PUBLIC HEARING/WORKING SESSION MEMORANDUM

PETITION #71-20

1114 Beacon Street

Response to Comments

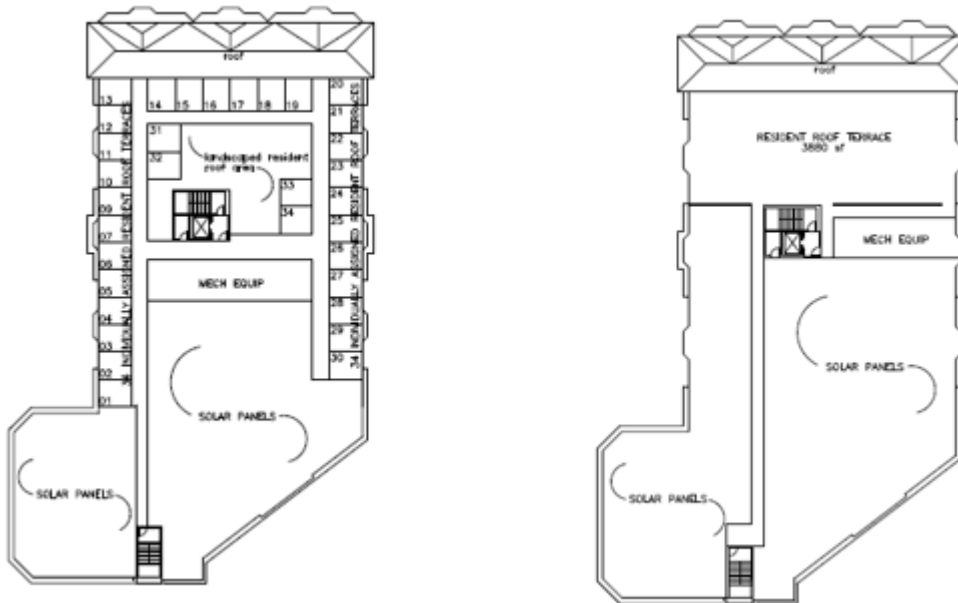
Members of the Committee requested clarification regarding the roof and the number of stories the structure contains. The petitioner stated that the roof will be an open-air deck with common space for unit

I would like a better understanding of the use of the roof and a better understanding of if it is a fourth story.

owners with a portion of the roof dedicated to a solar array. There is approximately 3,880 square feet dedicated to the common roof amenity space which is limited to the northern portion of the roof. The prior iteration of the project consisted of a greater area dedicated to amenity space as well as dedicated areas allocated to the specific unit owners.

The roof plan is included with the revised floor plans dated August 31, 2021. The proposed roof will be an open-air deck with common space for unit owners. A portion of the roof will also be used for a solar panel array. The roof is accessed by an enclosed stairwell which meets the definition of a story under the definition of "story" in the Zoning Ordinance. It is that enclosed stairway and the uninhabitable portion of the front façade above the third story that technically make the proposed project a "four-story" structure.
